**Windsor Bridge Replacement Project
Draft Urban Design and Landscape Plan Version 10
March 2017**

Community Action for Windsor Bridge

WINDSOR BRIDGE REPLACEMENT PROJECT
Version 10, Draft Windsor Bridge Replacement Project
Urban Design and Landscape Detailed Design Report

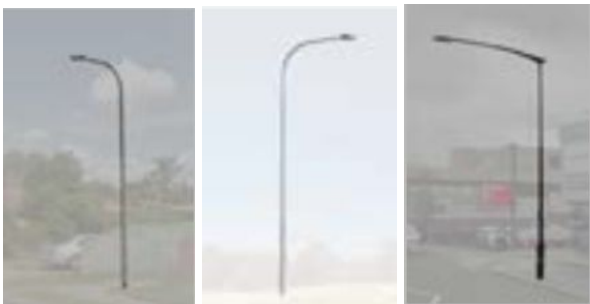
Well, the description of the lighting says, repeating words from the consent conditions, its architectural style will respect the "simple colonial georgian (sic) style", specifically, "Galvanised finishes to metalwork, will establish a simple, informal and utilitarian (sic) suite of lighting and thereby respect the colonial georgian (sic) style."

The following images from the UDLP Report, page 55, illustrate the RMS's proposed 'Georgian' style:

...which, unfortunately, looks nothing like genuine Georgian street lighting:

It is painfully evident the RMS has NOT designed lighting to fit in with the historic sensitivities of the Hawkesbury’s premier heritage tourism precinct, they have simply specified their standard lighting and described it as ‘Georgian’. This is not consistent with the spirit, or intent of the Conditions of Consent.

Figure 4.19: Eastern (downstream) elevation view of bridge from the river.

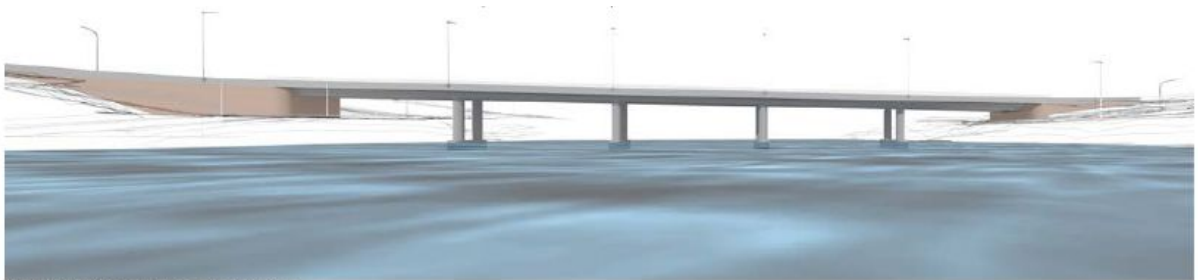
Given the draft Landscape Plan (page 16) says, “The deck of the bridge should be expressed as an uncluttered horizontal plane spanning the Hawkesbury River.”

And we are advised (page 32) the “longitudinal grades of the new deck (would) mirror, as closely as possible, the horizontal plane of the Hawkesbury River for the component of the bridge that spans between the abutments”

1. Why does the illustration of the bridge on page 34 (see below) appear to show the bridge deck as an inclined plane?

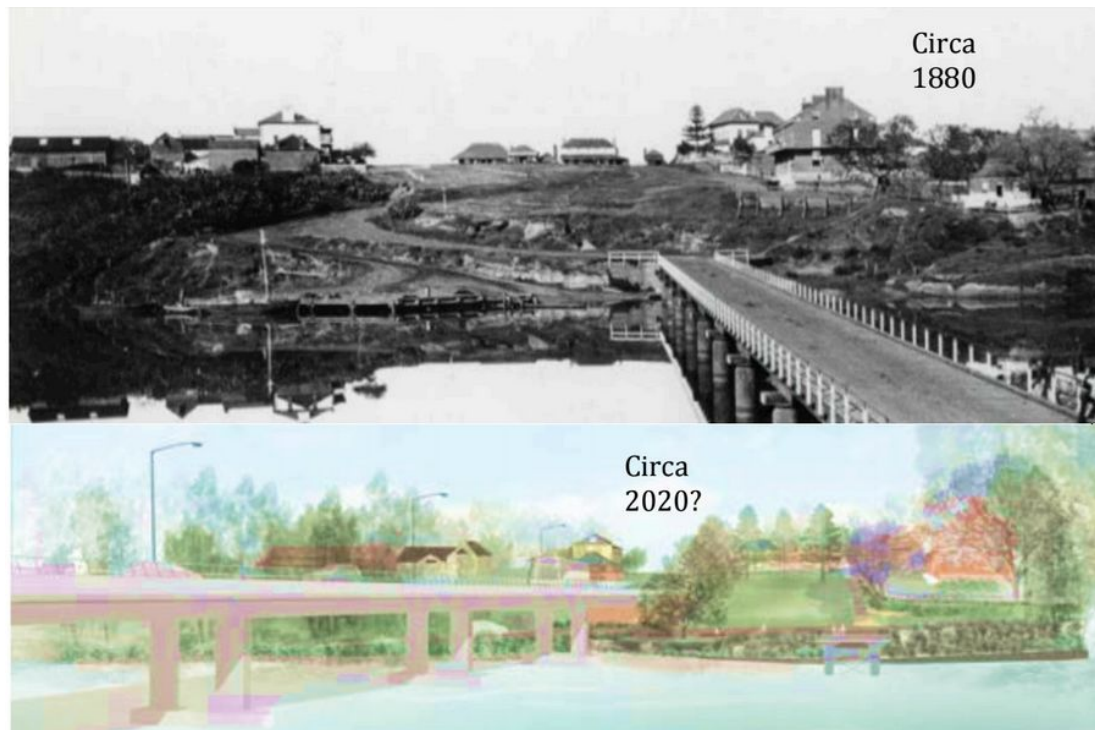
The claim WBRP will “Enhance the unique sense of arrival to Windsor both from the north and south while also strengthening the landscape character of historic Thompson Square through appropriate tree planting” is incorrect, indeed, absurd.

There will be no sense of arrival as can be clearly seen in the RMS flythrough:

1.) In this image Windsor is no longer a 'destination'. It is an invisible irrelevance on a longer journey. These screenshots make it painfully clear: the road leaps ahead, forging through and dominating an anodyne landscape. Its visual aggression and dominance promising a 'real' destinationsomewhere else. Keep going, faster, faster, the road whispers...

2.) The proposed tree planting, which predominantly creates a barrier between the road and the western side of the Square, seals Windsor's fate and terminally severs the relationship between all the various elements of the Square. Once full grown, the trees will ensure no one realises where they are. The trees will occlude the Square and focus attention on the road, not the place.

Thompson Square c2020:

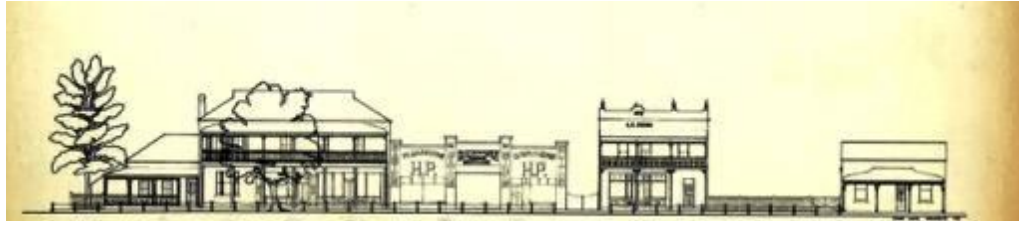
Scrutiny of landscape drawings indicate an absence of at least one iconic tree - the hoop pine in the upper section of the Square. Perhaps this is why exactly one hoop pine has been listed for planting in the southern precinct, a replacement for the original?

Large Hoop Pine no longer visible
